IN THE MATTER OF:  
INDEPENDENT ASSESSMENT PROGRAM -  
COMANCHE PEAK STEAM ELECTRIC STATION

DATE: THURSDAY, DECEMBER 20, 1984

The meeting between CYGNA and NRC Staff commenced at 9:00  
a.m., Vincent S. Noonan, NRC Director, Comanche Peak, presiding.

#### 5. Use of .6Fy for U-Bolts

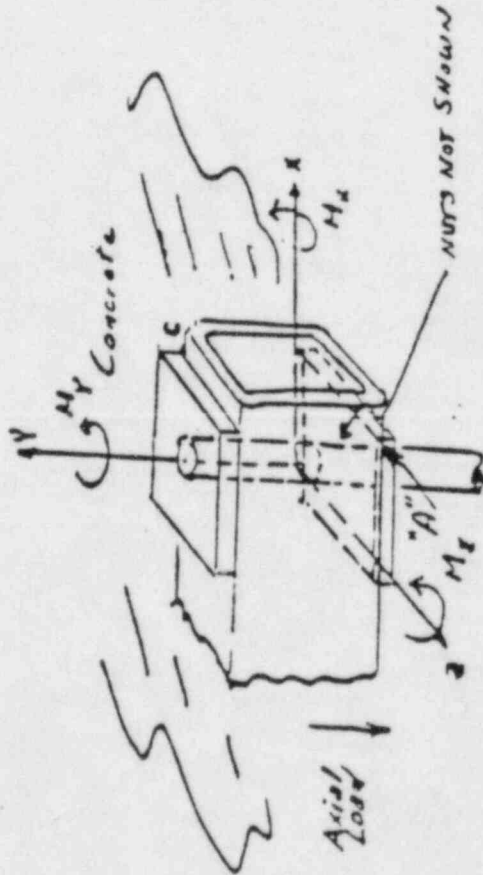
In designing the larger, non-standard U-bolts (i.e., 2-3/4" diameter rods, 2-1/4" diameter rods), the pipe support organizations have used an allowable tensile stress of .6Fy; actual bolt stresses were based on the tensile area of the threaded region. This conforms with the ASME Code Section III, Appendix XVII, Paragraph XVII-2211. In order to provide further justification for this procedure, ITI Grinnell performed a test program for 1/2" diameter and 1" diameter U-bolts (Reference Attachment to TUGCO letter dated May 2, 1984). Based on the results of those tests, ITI has shown quite clearly that .6Fy is an acceptable tensile stress allowable for U-bolts.
